Project #:	605-16-610	RFI #:	001
Project Name:	Building 2640, March Air Reserve Base, CA	Date Requested:	01/25/17
Solicitation No.:	VA262-17-B-0178	Reference:	Illegible Drawings
Drawing:	All except A-1	Specification Section:	N/A

Project #:	605-16-610	RFI #:	011
Project Name:	Renovate Building 2640, March ARB	Date Requested:	2/2/17
Solicitation No.:	VA26217B0178	Reference:	
Drawing:		Specification Section:	Scope of work
DESCRIPTION OF PROBLEM OR INFORMATION REQUESTED			
It was mentioned at the site visit on 2/1/17 that the scope of work was incorrect. Please provide a revised and detailed scope of work and plans to reflect the scope.			
OWNER RESPONSE			
Scope of work accurately reflects the VA's requirements.			
OWNER TRACKING No.:		AMEND No.:	
VA Project Engineer/Manager: T LaFave		Date: 2/8/2017

VA PHASE I

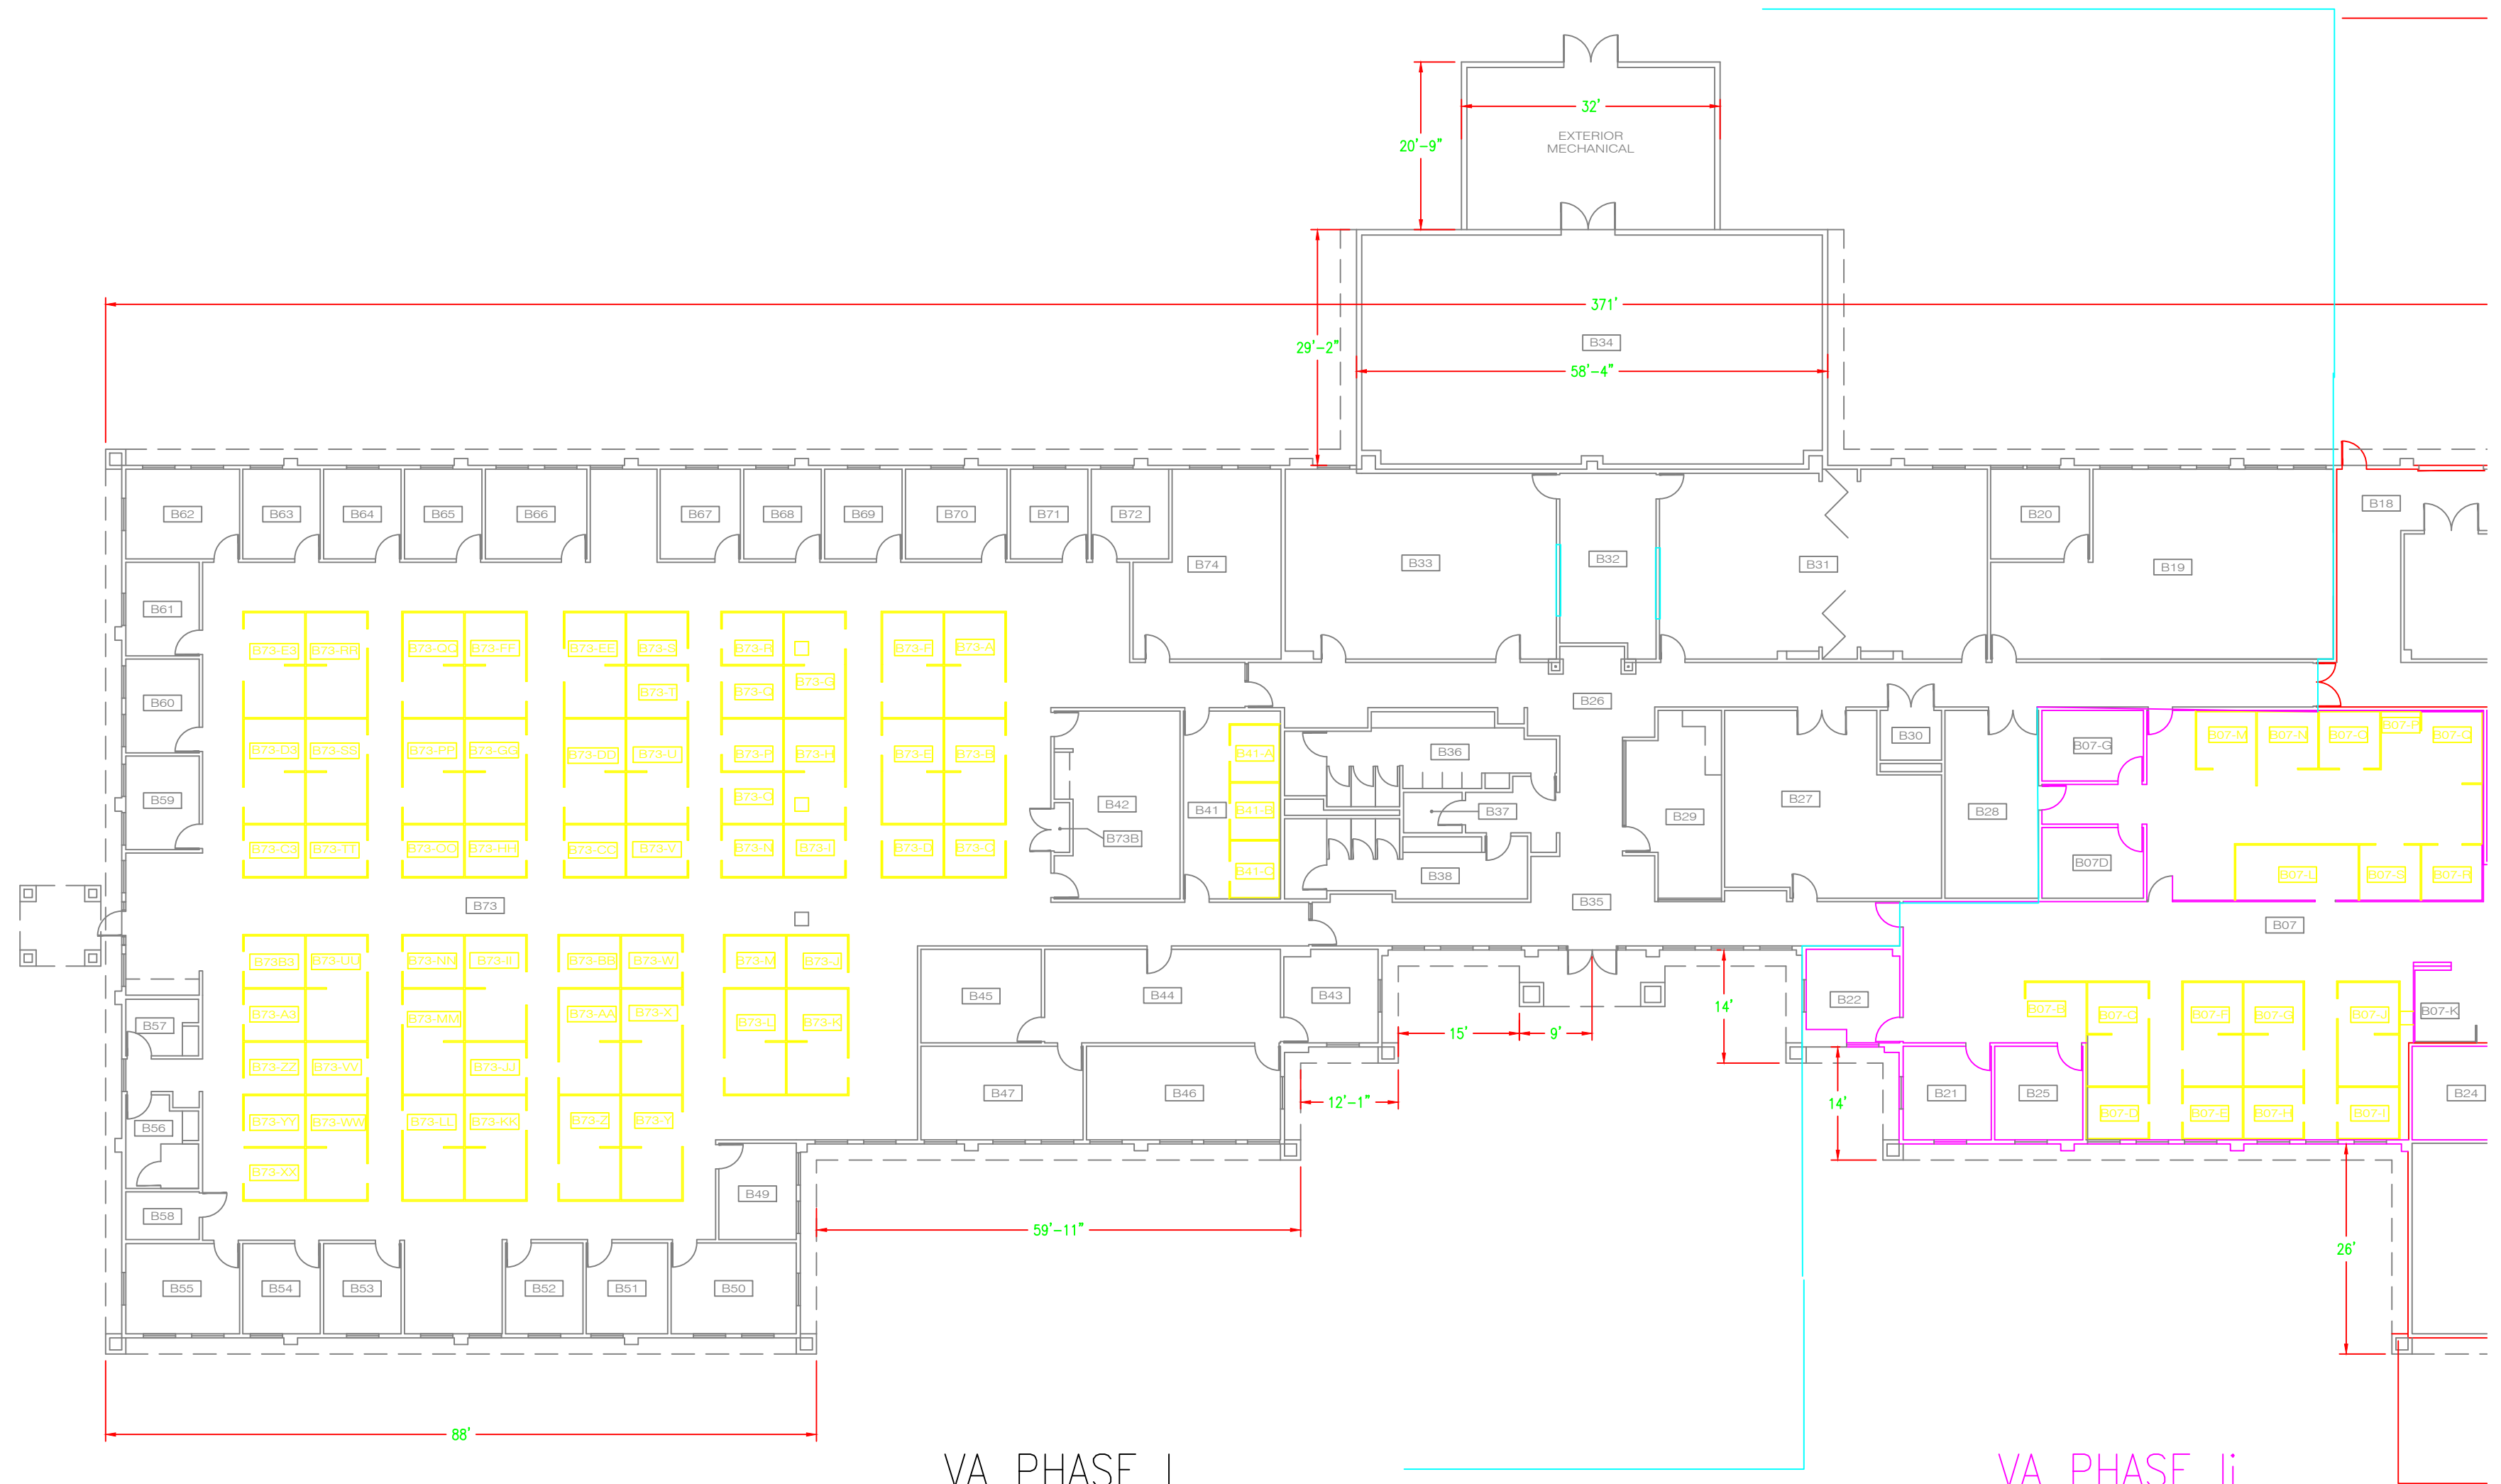
Project #:	605-16-610	RFI #:	033
Project Name:	Renovate Building 2640, March ARB	Date Requested:	2/8/17
Solicitation No.:	VA26217B0178	Reference:	
Drawing:	A-1	Specification Section:	Scope of Work

There is no work shown to be done in the Phase 2 or USMC section of the plans but it does not specify that they are not included.

Please verify that we are only to bid for the outlined Phase 1 section.

Correct, bid outlined phase 1 section
